ADDENDUM # E001

PROJECT NAME: 400 West Hunt Club – Star Motors

PROJECT #: 24094

Reference Electrical Drawings, Issued for Tender, June 3, 2025.

RYTEC CORPORATION
ONE CEDAR PARKWAY, JACKSON, WI 53037-0403
Spiral Door with SYSTEM 4 Drive and Control.
Electrical Scope Of Work

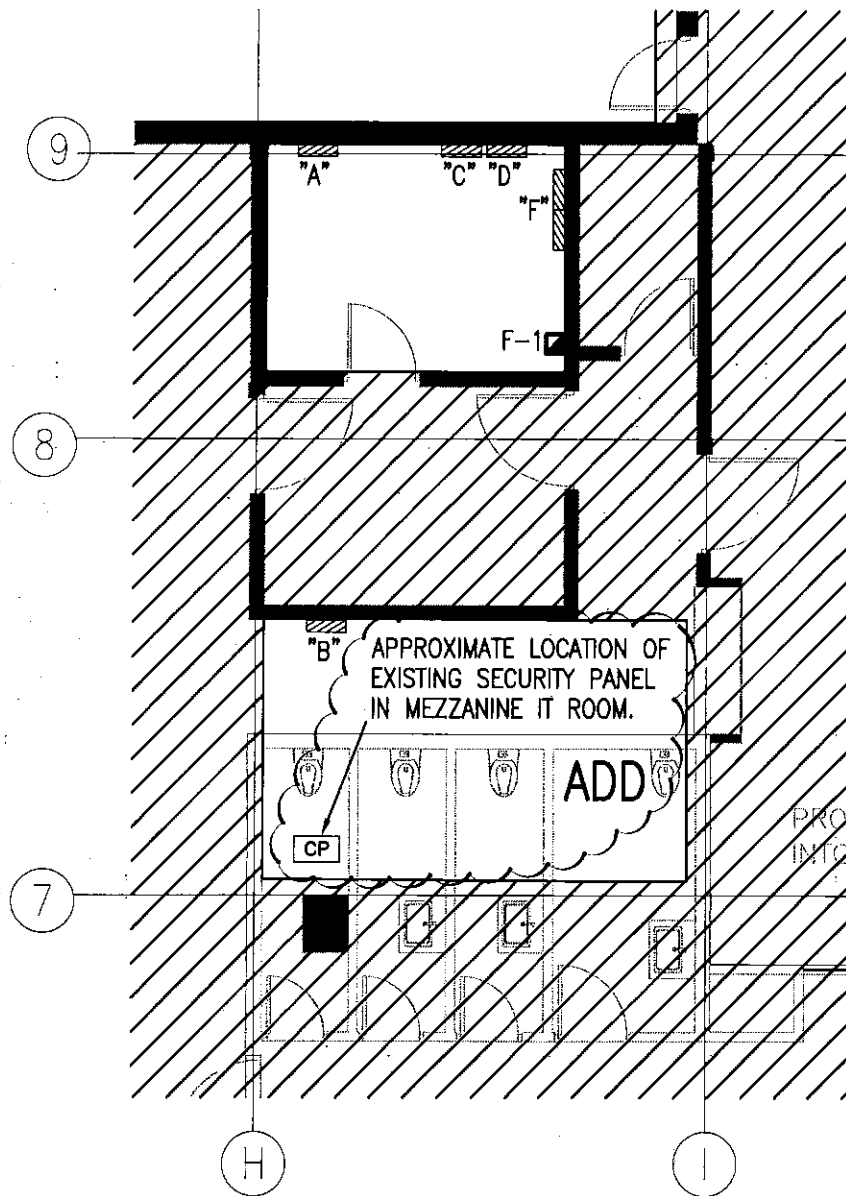
1. Note 2 on drawing E-3 states 'Overhead doors and controls are supplied by the owner, installed by electrical. Refer to client supplied Rytec Corporation "Electrical Scope of work" documents. These documents are not present on the electrical documents. We wire and install the controls and the motors. Installation of motors and door systems is by others.

McKee: Refer to attached sketch "Electrical Scope of Work".
